HI-STORM 100 LAR 1014-5 RAIs #2 Responses

Holtec International
June 28, 2006

RAI 2-1

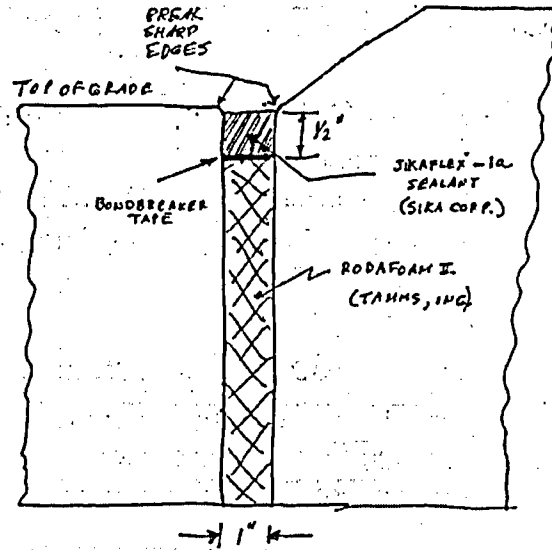
- 2-1 Details of joint between top pad and transporter riding surface
 - Details are added to Licensing Drawing 4501
- 2-2 Visual Inspection of caulking around the CEC
 - Visual surveillance requirements are already specified in Table 9.1.1 of Supplement 9.1. They require annual surveillance of the interface

Expanded Representative Simulation (MPC Lid removed for clarity)

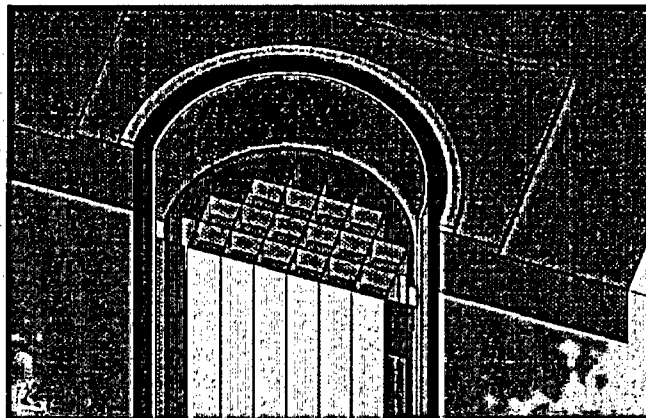
- 3-4, 3-7, 3-8, 3-11, 3-13
 - Holtec is revising FSAR and TS to ensure that every site owner shall perform a site specific analysis using the methodology set forth in the FSAR and used in the representative solutions presented in the FSAR. All inferences that the site owner can opt to demonstrate that the representative solutions are bounding (and therefore, no new solution must be performed) are being removed from the TS.
 - The representative solution in the FSAR will be the solution already presented with the addition of the divider shell, the MPC upper and lower guides, the MPC, the fuel basket, and fuel in each cell. The MPC-32 will be the representative MPC and all nominal gaps will be simulated.

- 3-4, 3-7, 3-8, 3-11; 3-13 (cont.)
 - The top-of-foundation is still driven and is assumed to be bedrock (no flexibility); one VVM is considered; the lid is included with the correct load path and mass modeled. **SINCE THIS IS TO REPRESENT A TYPICAL SOLUTION SOLELY TO PROVIDE AN APPLICATION OF THE METHODOLOGY, NO EVALUATION OF THE EFFECT OF MULTIPLE VVM'S, FLEXIBLE PAD, EXTENT OF SURROUNDING SUBSTRATE, SUBSTRATE UNDER PAD DOWN TO BEDROCK IS INCLUDED.** The applicable methodology is spelled out in the written response to RAIs 3-4 and 3-7, and is to be put in the FSAR, and specifically referred to in the TS.
